PIER TOP PLATE INSTALLATION DIAGRAM FOR CG-5 TYPE MOUNTS

ADDENDUM

INSTALLATION DIAGRAM STANDARD PIER TOP PLATE

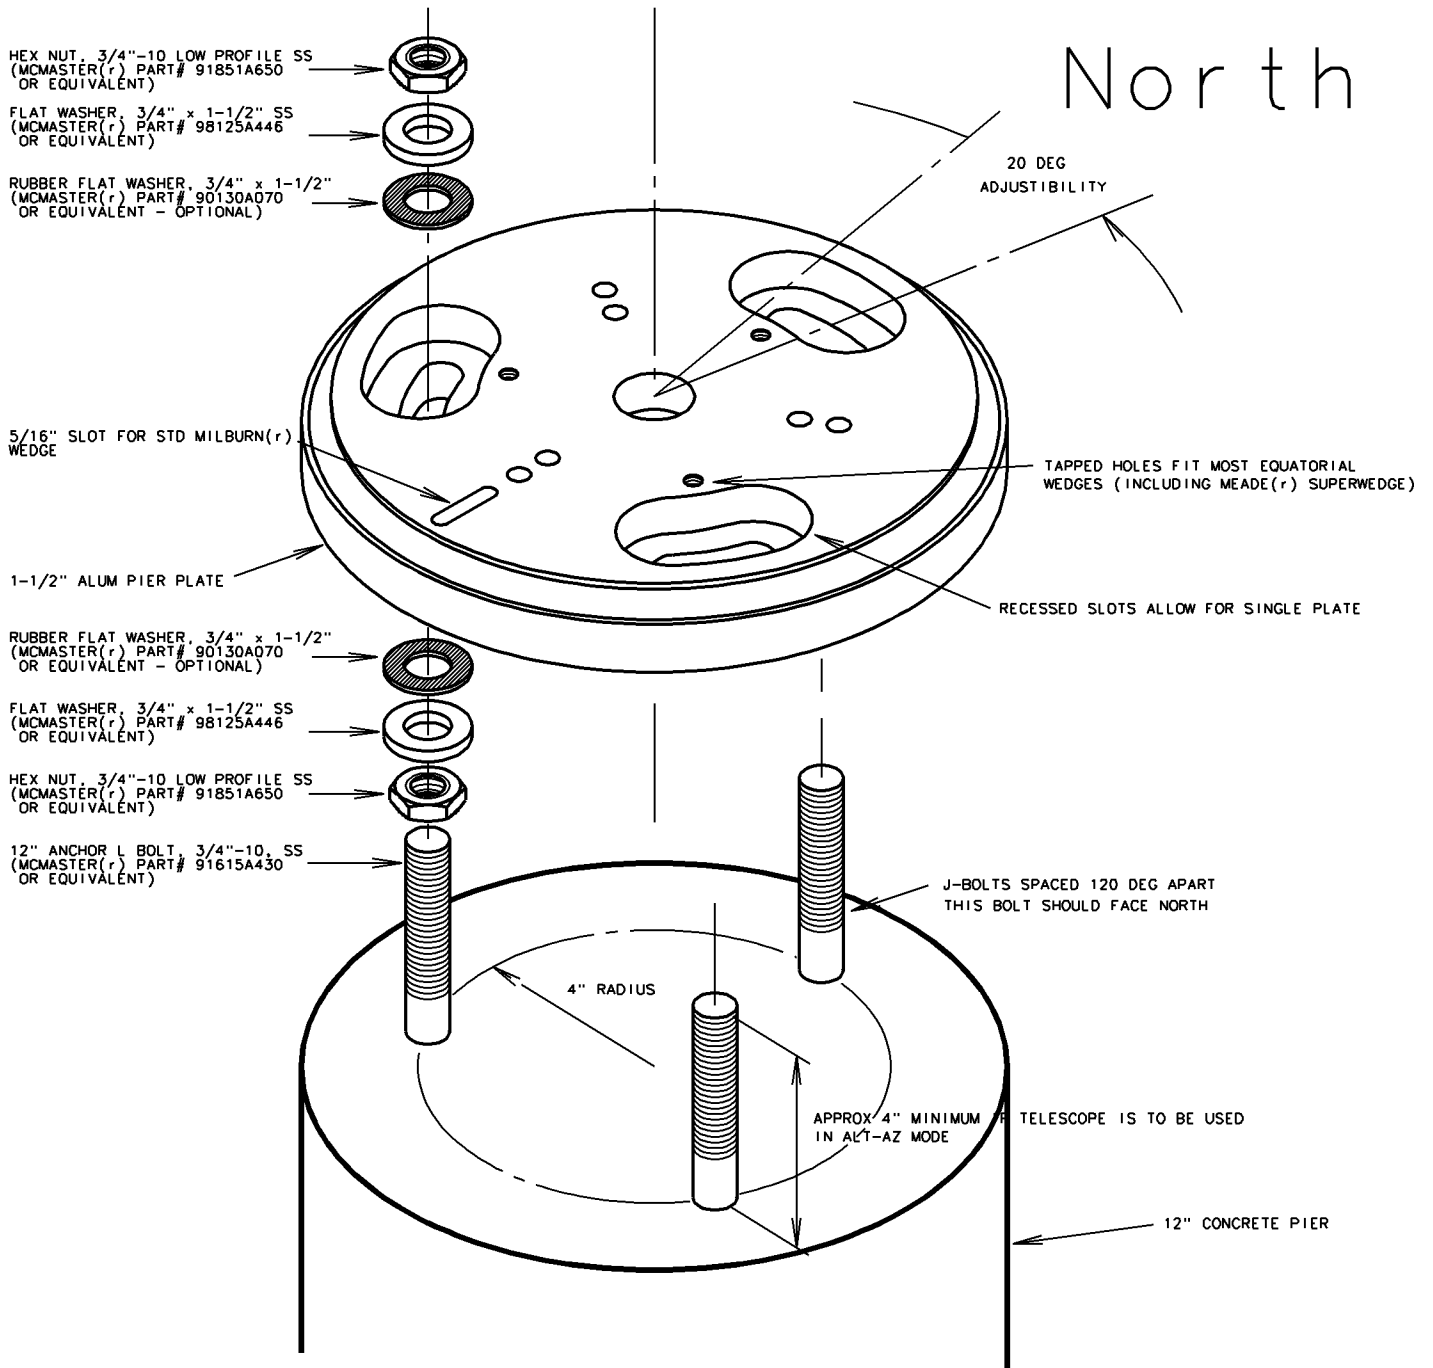
MANY CUSTOMERS HAVE ASKED US TO ENLARGE THE SIZE OF THE MOUNTING SLOTS OF OUR 12" PIER TOP PLATES TO MAKE UP FOR IMPERFECT BOLT ALIGNMENT. ALL 12" PLATES NOW HAVE WIDER MOUNTING SLOTS AND ALSO INCLUDE AN OPTIONAL BRONZE SLEEVE BEARING THAT SLIDES OVER THE ANCHOR BOLT TO PROTECT THE PLATE FROM THE ANCHOR BOLT THREADS. IF MORE LEEWAY IS NEEDED TO MOUNT THE PLATE, THE BRONZE SLEEVE BEARING MAY BE OMITTED.

BRONZE SLEEVE BEARING
(INCLUDED IN NEW 12" PIER
TOP PLATES)
